Bulletin | Danfoss Turbocor Compressors

Customer Notification

B-CN-104-EN Rev A

SUBJECT: Notice of Implementation – TT/TG Series Fastener Change

Figure 1 – Impacted Fasteners

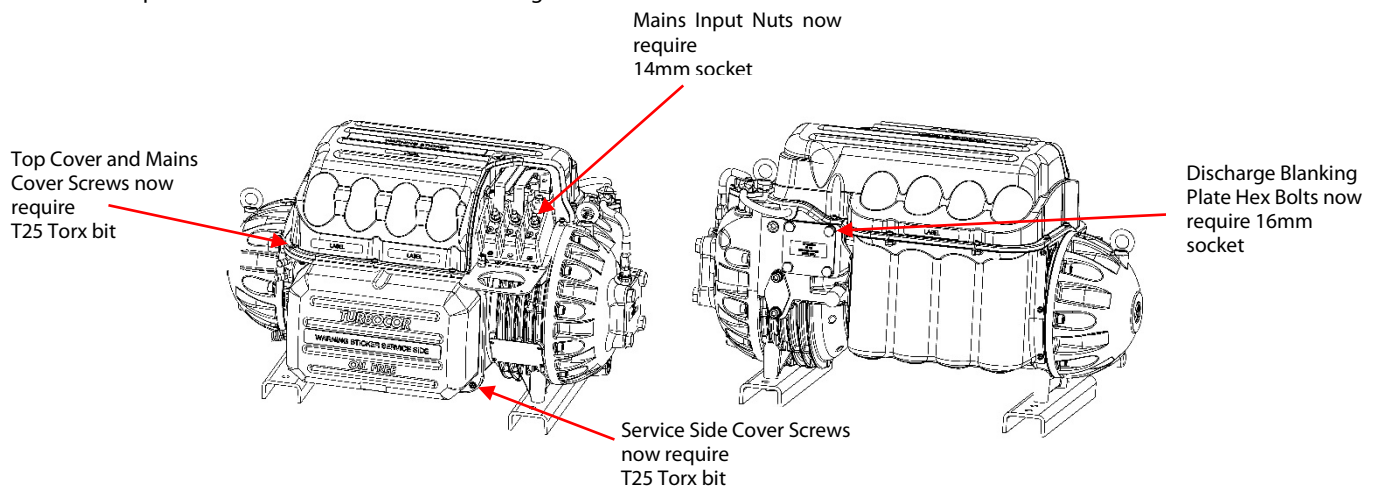
As previously mentioned, some screws with a Philips head will be changed to either a Torx (T25/T45) or hex head. However, there are no changes to the torque values of the impacted fasteners. Further fasteners are impacted, however, only those impacting the installation of the compressor are identified. Refer to Figure 1 – Impacted Fasteners.

Some of the impacted fasteners are shown below in Figure 1.

Customers however should be aware that there will be a few changes to the size of the tools required to install the compressor. Again, there are no changes to the impacted fastener torque values.
